BENCOR 2ND ADDITION
WICHITA, SEDGWICK COUNTY, KANSAS

RE: SUB 2000-10 -- Final Plat of BENCOR SECOND ADDITION

CASE NUMBER: SUB 2000-10 -- BENCOR 2ND ADDITION

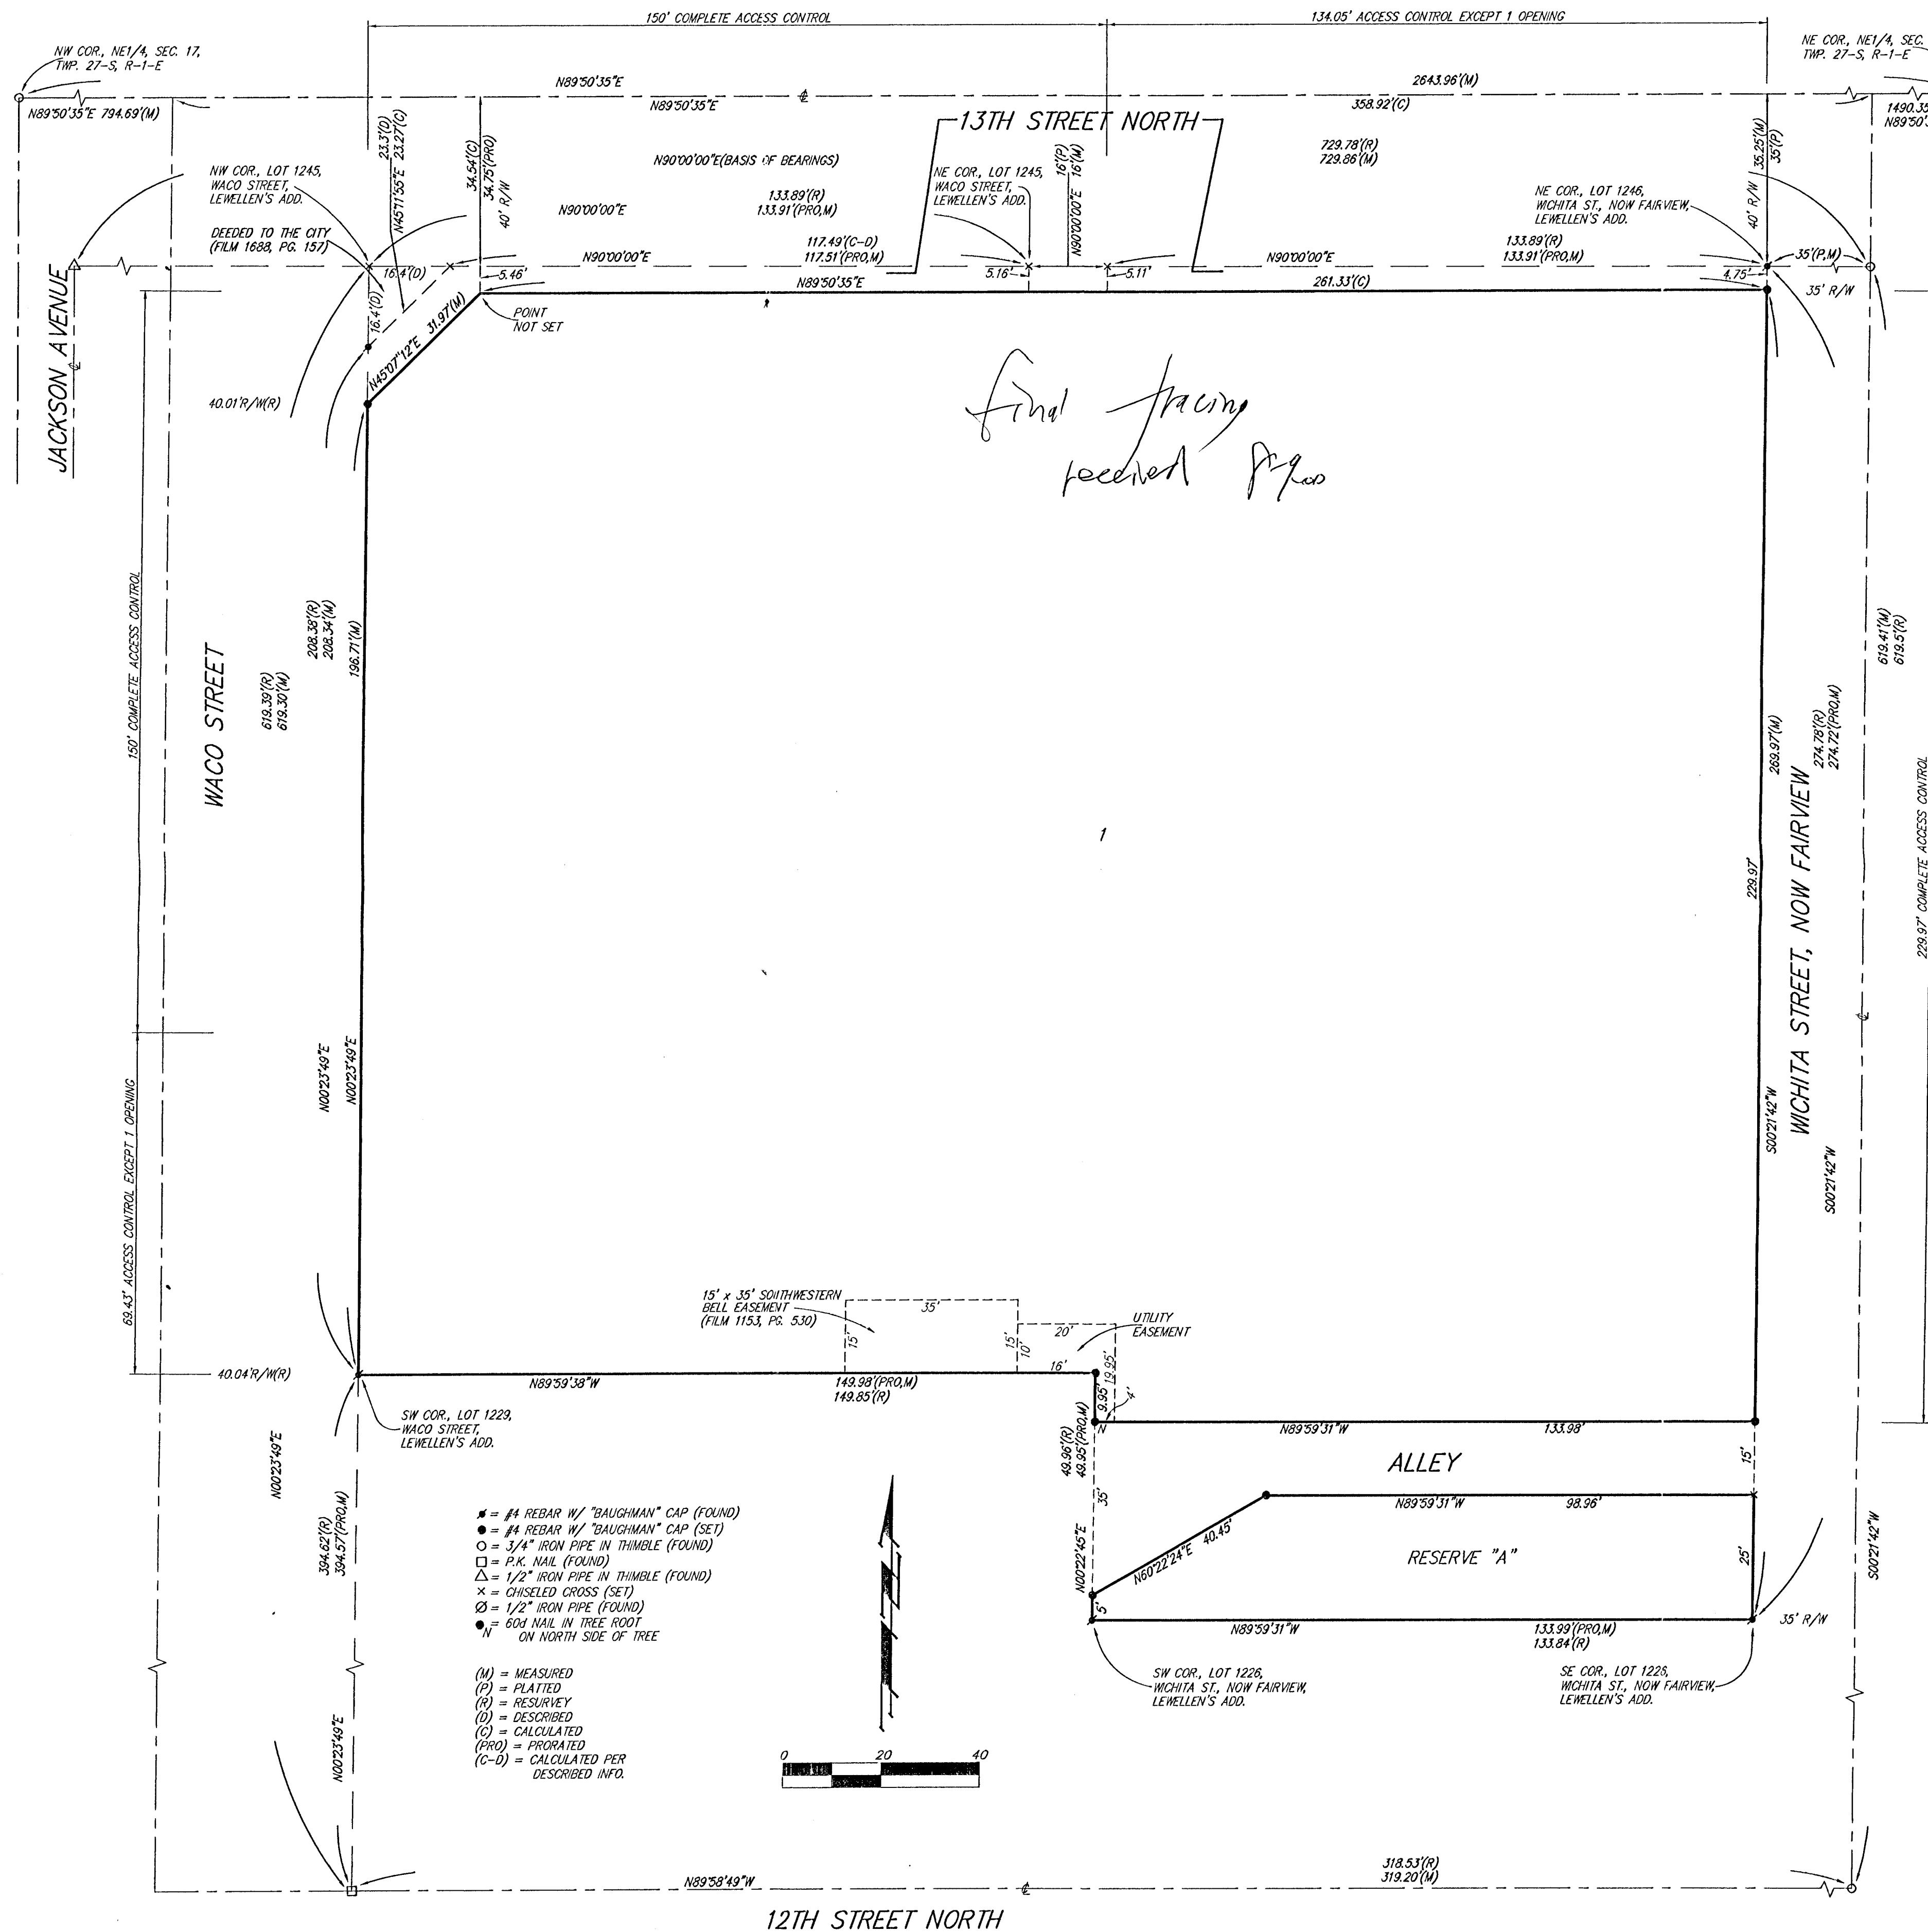
- A. Municipal services are available to serve the site. **City Engineering** needs to comment on the need for any easements or guarantees. *A guarantee shall be submitted for abandonment of the existing sewer line. A temporary easement should be established to cover the sewer line until abandonment.*

- C. **City Engineering** needs to comment on the status of the applicant's drainage plan. *The drainage plan is approved.*
- D. The plat proposes one access opening along both Waco and 13th St. North. In accordance with the approved site plan, no access openings are proposed along Fairview, and complete access control should be dedicated along Fairview. Distances should be shown for all segments of access control. The dedication of access controls shall be referenced in the plat's text. In accordance with the Subdivision regulations, any access openings located within 250 feet of the intersection of 13th St. North and Waco are limited to right-turns only, and shall be referenced on the face of the plat; or a guarantee provided for the future construction of a raised medial.

- F. **Traffic Engineering** needs to comment on the need for additional right-of-way for 13th St. North or Waco. A 50-ft half-street right-of-way is typically required for arterials. *Traffic Engineering has approved a 40-ft half-street right-of-way.*

- I. A "Notice of Protective Overlay" document indicating the Protective Overlay has been filed with the MAPD shall be submitted.
- J. The legal description shall be revised to reference Lot 1226 of the Lewellen's Addition and include a metes and bounds description of Reserve A.

- K. The plat's text shall include language that a drainage plan has been developed for the plat and that all drainage easements, rights-of-way, or reserves shall remain at established grades or as modified with the approval of the applicable City or County Engineer, and unobstructed to allow for the conveyance of stormwater.

- S. The representatives from the utility companies should be prepared to comment on the need for any additional utility easements to be platted on this property. Southwestern Bell requests that the vacated alley be retained as a utility easement. Any relocation or reconstruction of utilities made necessary by this plat shall be the responsibility of the Applicant.

- U. The applicant shall guarantee the paving of the proposed alley.
